| MATERIAL      | -       | DRAWN BY           | S.Y.EUN |                                                                                       | TITLE<br>MMCX50 PCB J-4R                                                                                                                                              |
| <div>A4</div> |         |                    |         |                                                                                       | DWG NO. CN00015-7/6                                                                                                                                                   |

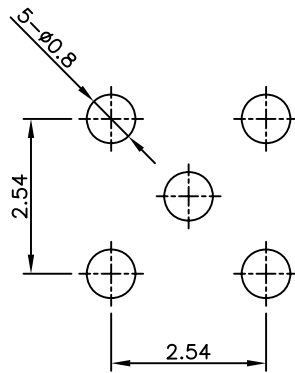
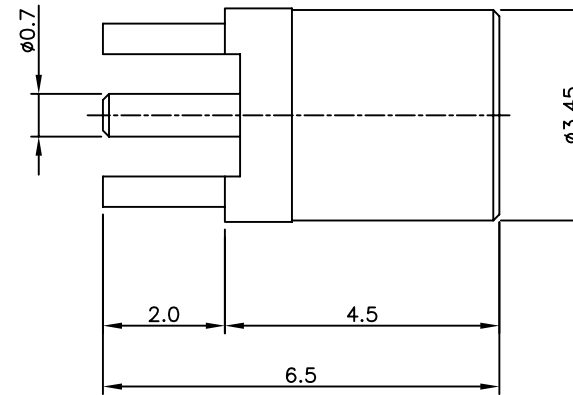
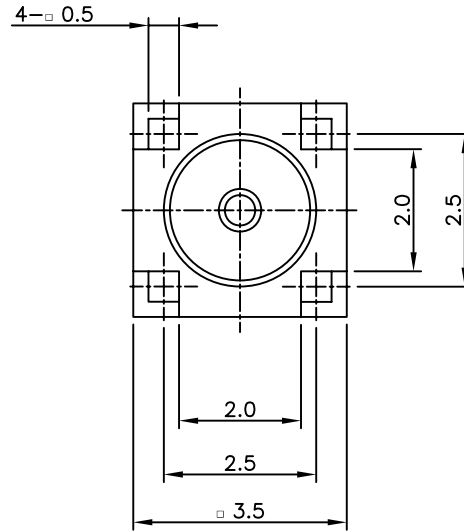
| REVISION |                             |         |         |               |
|----------|-----------------------------|---------|---------|---------------|
| ↑        | 절연체 가공문제로 인한 내부단차 → 내부일자 변경 | S.Y.EUN | I.C.KIM | 2018. 03. 07. |

| 3   | INSULATOR   | 1    | TEFLON             |            | DIN01671-N/2<br><del>DIN01671-N/1</del> |
